#### ANN ARBOR HISTORIC DISTRICT COMMISSION

#### **Staff Report**

ADDRESS: 611 East William Street, Application Number HDC17-257

**APPLICATION:** The applicant seeks HDC approval to replace the front door with a replica of the original door in order to meet building code requirements; and to install two bracketed banner signs on the front of the building and one small sign on the brick wall that surrounds the property.

SK-1 Sheet No.

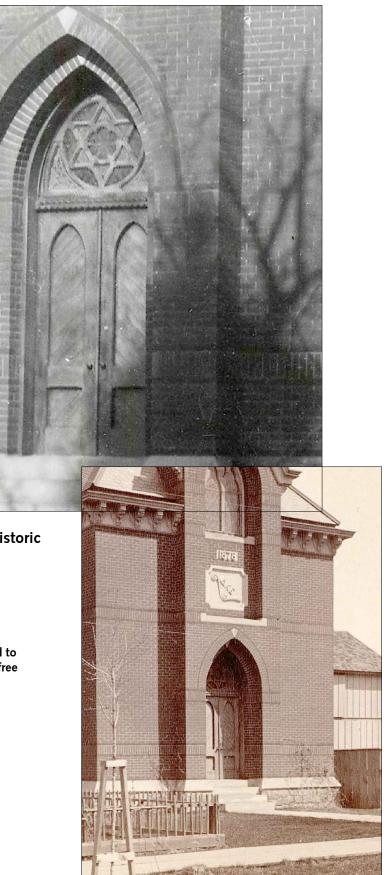
- 1. The current doors are very similar to photos of the original doors, but the diagonal panels are missing; the shadow line around the panels is not as deep, and it looks from photographs like the center and bottom "rails" are the same height. If you blow up the historic photos, the bottom rail looks taller than the center one. Staff's best guess is that this is not the original door, but a very similar replacement of unknown age that maintains the basic style and proportions of the original.

- 2. Staff believes the petitioner diligently pursued ways to keep these doors in place, but was stymied by building code requirements. The proposed new door is slightly narrower than the current one, but maintains the proportions of the existing and incorporates elements of the historic front door. It is a single door designed to look like a pair. Staff believes this is an appropriate treatment of the door to allow safety codes to be met while retaining the historic character of this extremely significant building.

# FRONT ELEVATION WITH SCREEN WALL AND GATE

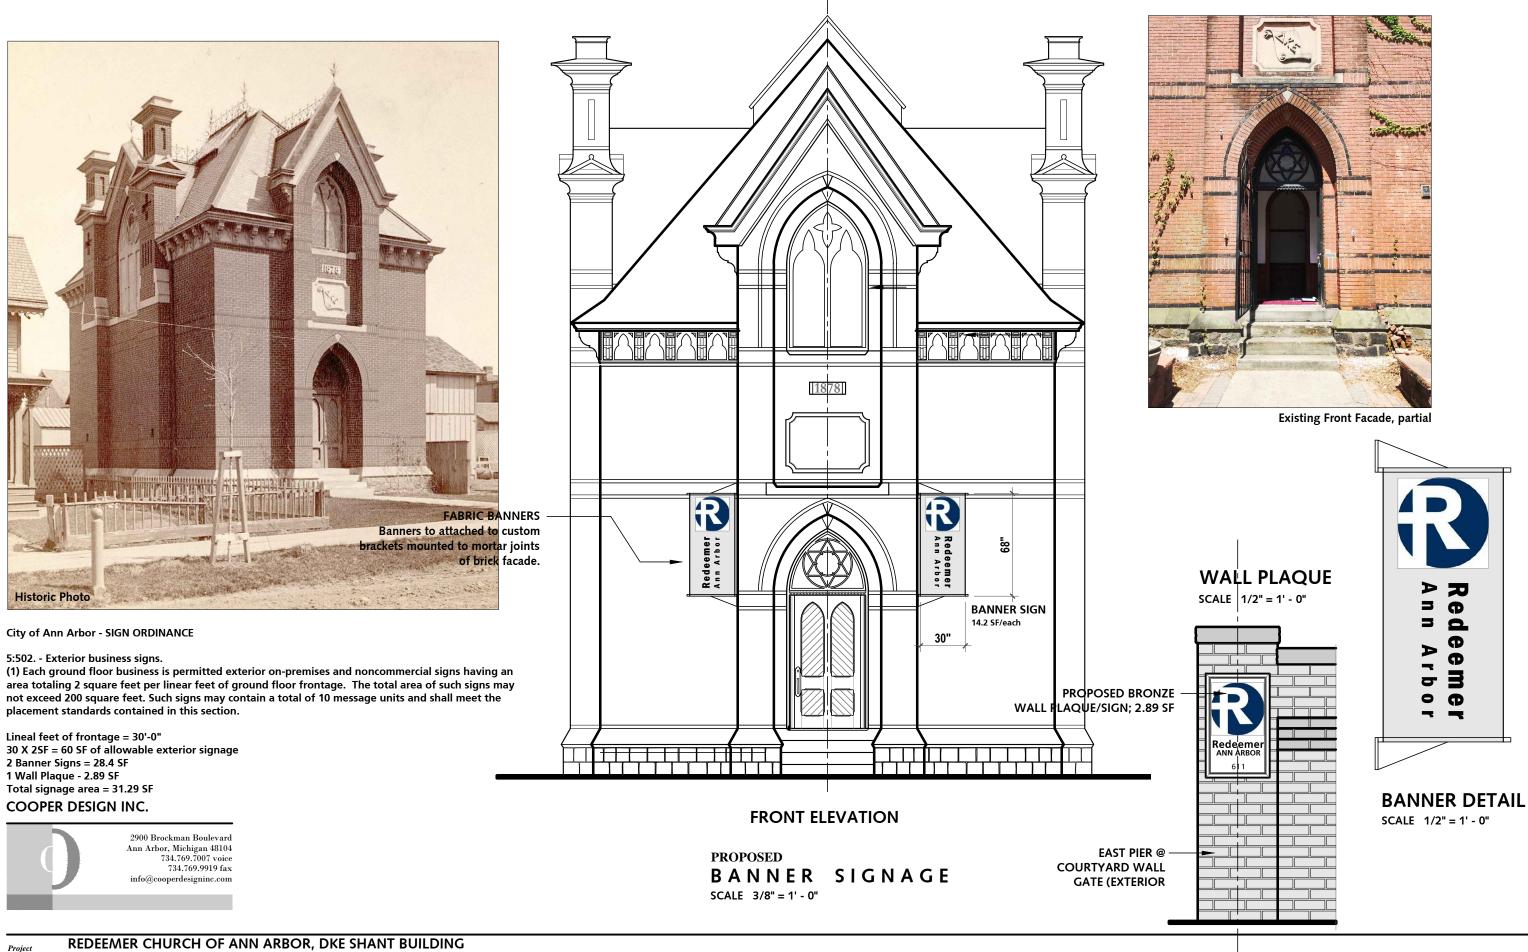
- 3. The banner signs are proportioned correctly and mounted in a way that is minimally invasive to the building and reversible. The bronze plaque on the front wall is scaled to fit the gate pier and is also reversible.
